# CITY OF ALBUQUERQUE

**RE: Starbucks at Peroglyph Plaza  
Grading Plan  
Stamp Date: 4/14/17  
Hydrology File: C12D001G4**

Based upon the information provided in your submittal received 4/18/2017, the Grading Plan is **not** approved for Building Permit. The following comments need to be addressed for approval of the above referenced project:

ENGINEER'S SEAL	STARBUCKS PETROGLYPH PLAZA	DRAWN BY WCWJ
	<b>GRADING AND DRAINAGE PLAN</b>   Rio Grande Engineering 1606 CENTRAL AVENUE SE SUITE 201 ALBUQUERQUE, NM 87106 (505) 872-0999	DATE 4-14-17
		21719-LAYOUT-3-16-17
DAVID SOULE P.E. #14522		SHEET # —
		JOB # 21719

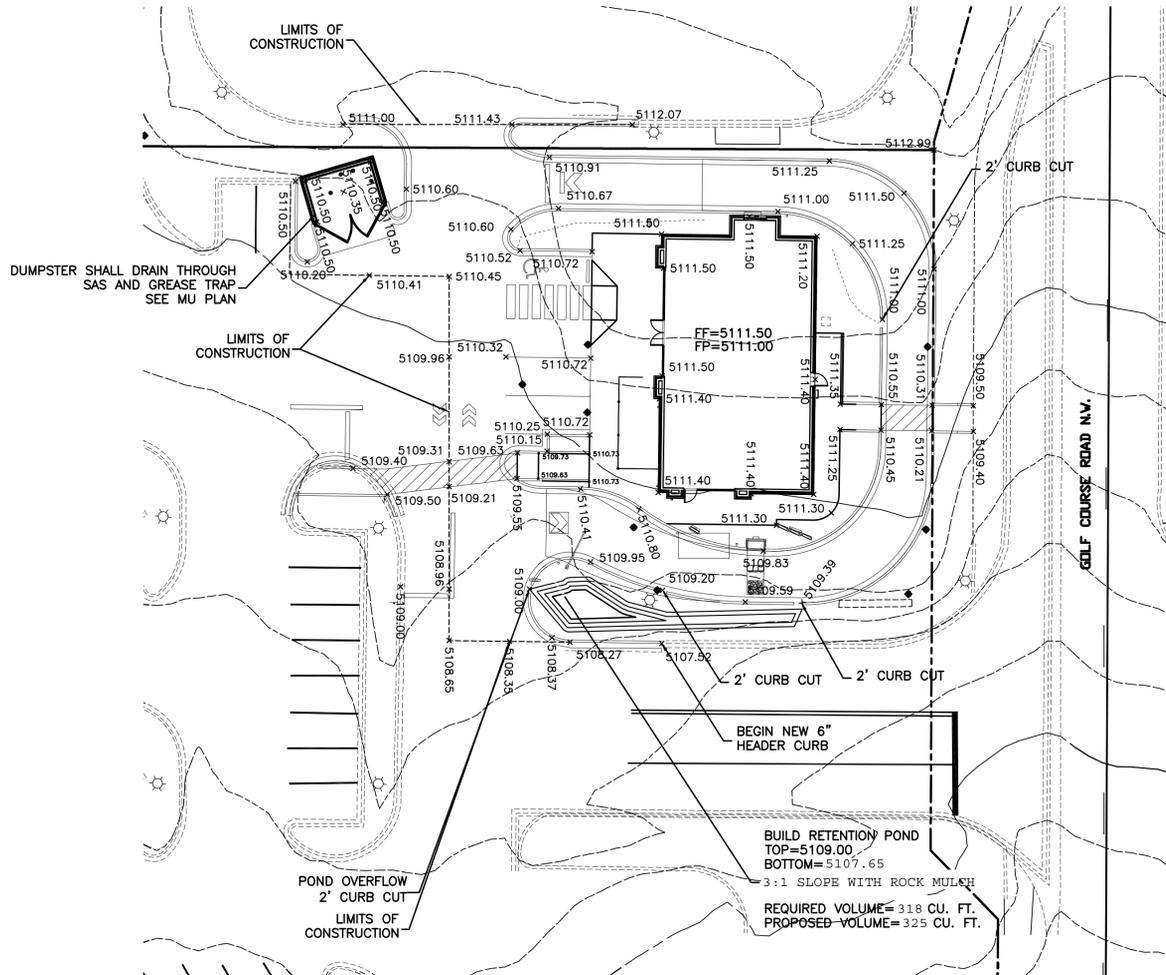
1. Please provide the benchmark information for the survey contour information provided.
2. After reviewing the proposed grades for the first flush pond and the existing contours nearby, it appear the northern top of pond contour is 5109 but the southern top of pond contour appears to be 5108. Both of these contours should be regraded to the existing corresponding contour line. The proposed pond has a bottom at 5107.65 with 3:1 slope. The drawn pond appears to have a height of 1 foot, therefore the top of the pond appears to be 5108.65. Please verify the proposed pond's shape and volume. Also tie any proposed contour lines to the existing ones around the pond.
